**Nomination Form
Anadromous Waters Catalog**

Anadromous Waters Catalog Number of Water Body 223-30-13240 (-0010)

Name of Water Body *Yale Pond (and Creek) USGS Name Local Name
 Addition Deletion Correction Backup Information

| Nomination # | <u>25-853</u> | | <u>12/09/2025</u> |

Map #1

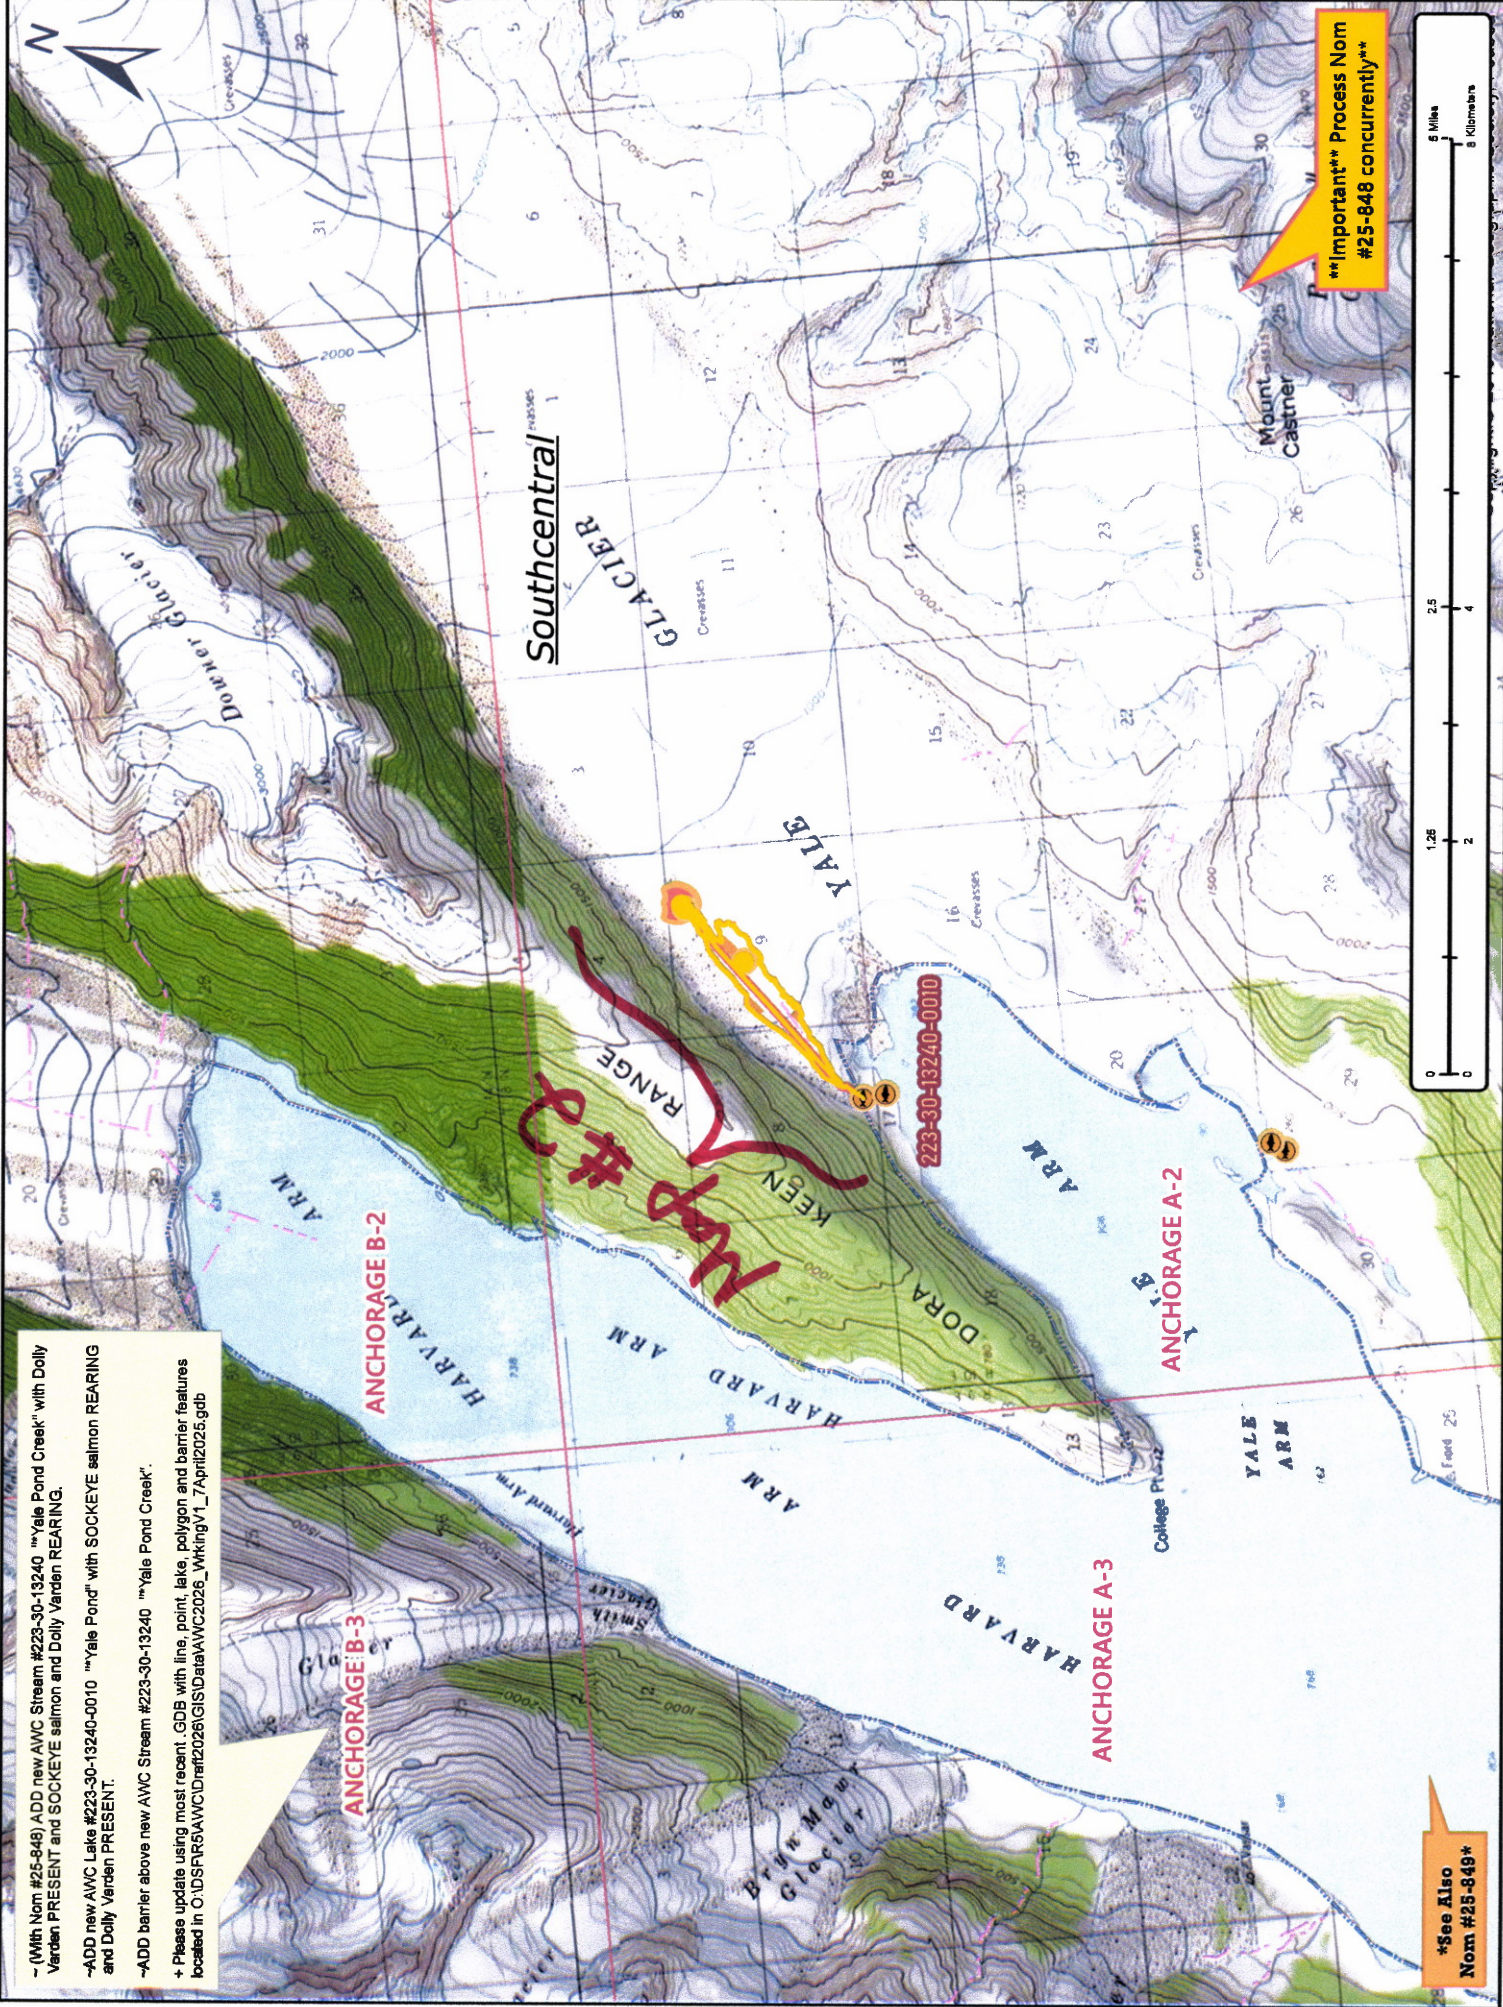
~(With Nom #25-848) ADD new AWC Stream #223-30-13240 "Yale Pond Creek" with Dolly Varden PRESENT and SOCKEYE salmon and Dolly Varden REARING.
 -ADD new AWC Lake #223-30-13240-0010 "Yale Pond" with SOCKEYE salmon REARING and Dolly Varden PRESENT.
 -ADD barrier above new AWC Stream #223-30-13240 "Yale Pond Creek".
 + Please update using most recent GDB with line, point, lake, polygon and barrier features located in O:\D\S\RF5\AWC\ID\nt2026\GIS\Data\AWC2026_WkingV1_7Apr12025.gdb

Map # 2

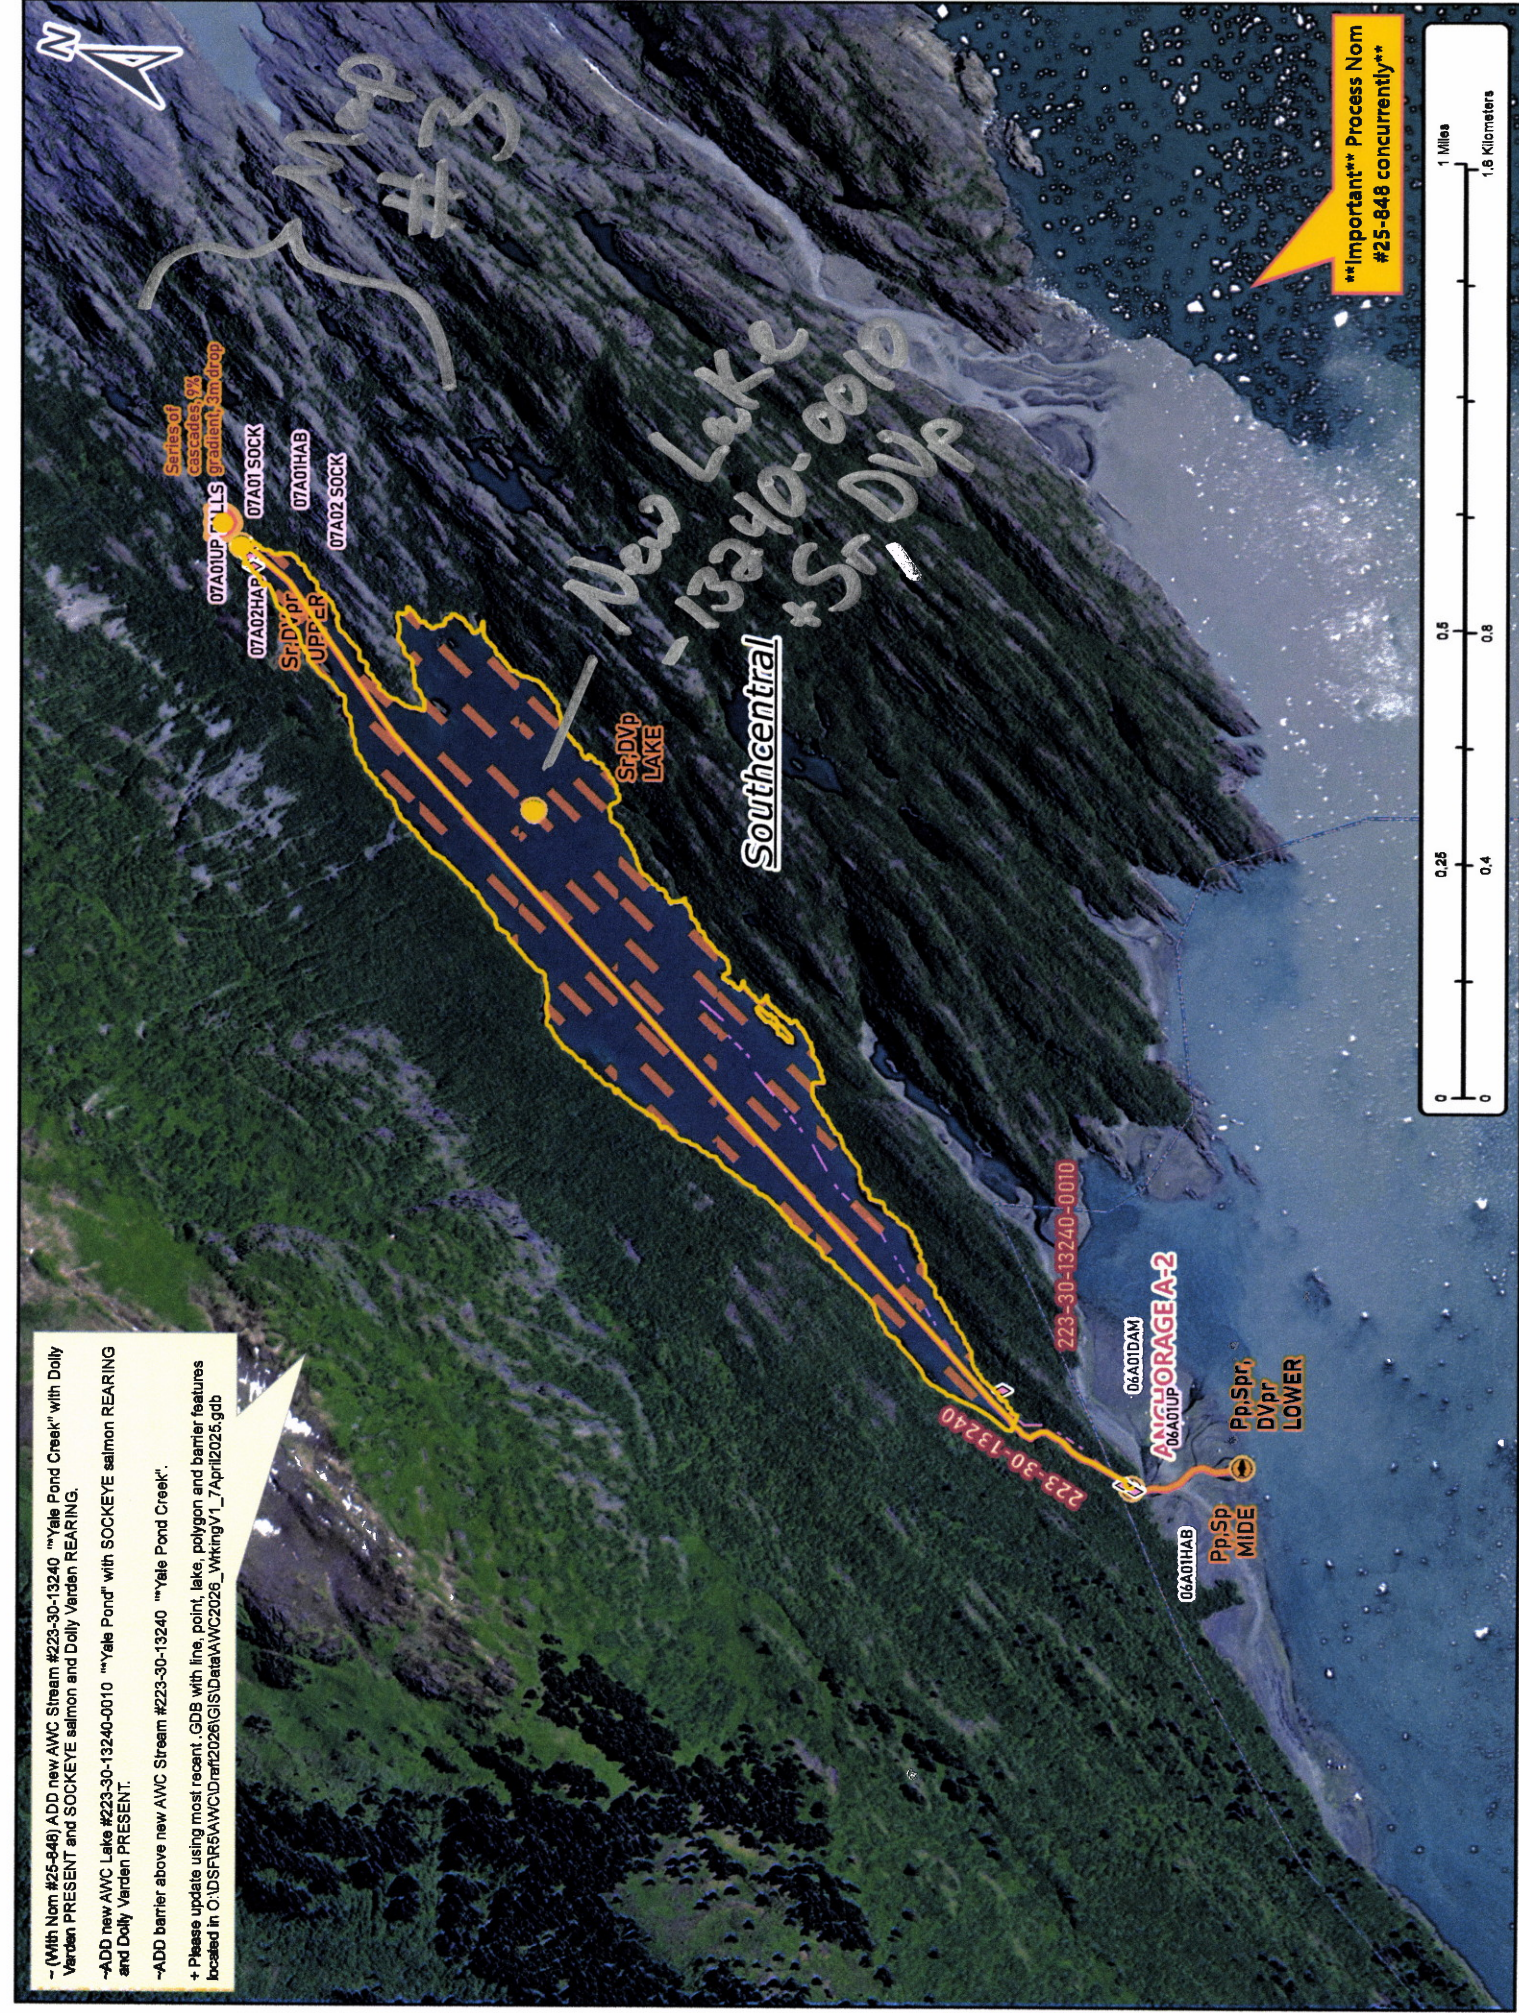
- (With Nom #25-848) ADD new AWC Stream #223-30-13240 "Yale Pond Creek" with Dolly Varden PRESENT and SOCKEYE salmon and Dolly Varden REARING.
 -ADD new AWC Lake #223-30-13240-0010 "Yale Pond" with SOCKEYE salmon REARING and Dolly Varden PRESENT.
 -ADD barrier above new AWC Stream #223-30-13240 "Yale Pond Creek".
 + Please update using most recent GDB with line, point, lake, polygon and barrier features located in C:\DS\FIR5\AWC\ID\ref12026\GIS\Data\AWC2026_WrkingV1_7April2025.gdb
